**Lentoasemanpuisto ideas competition** First round of questions (deadline 05-06-2020)

Figure 3 - Zones and functions in the Malmin kenttä area

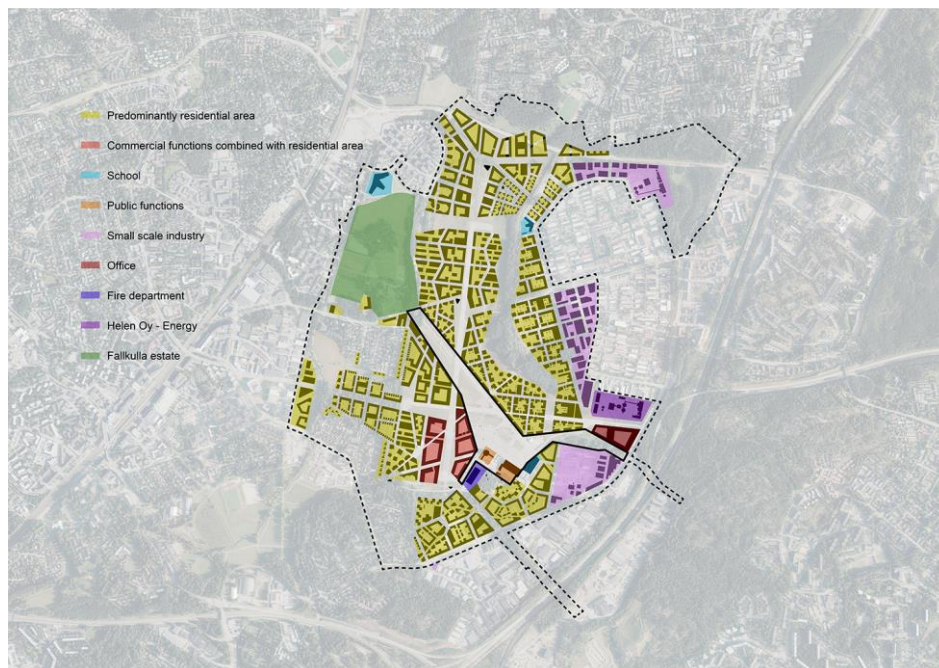
*“Could we get a legend to the masterplan presented on page 16 of the brief document?”*

*“Can we get detailed information on envisaged building active uses/ ground floor functions around the park?”*

A legend for the master plan of the Malmin kenttä area is not available. To give an overview of the functions in the area, a map containing various zones and functions is presented in Figure 3. The centre of the Malmin kenttä area is located west of Lentoasemanpuisto. The biggest share of commercial activity is planned to be located in this area. The predominantly residential areas will contain spaces for supermarkets, cafes and kindergartens. A bigger school is located south-east of the park. In the eastern part of Lentoasemanpuisto, the park is bordered by office spaces and small scale industry. The competitors are encouraged to think about the relation between possible commercial and public activities at the borders of the park and Lentoasemanpuisto itself. Furthermore, a new function should be proposed for the terminal and hangar area.
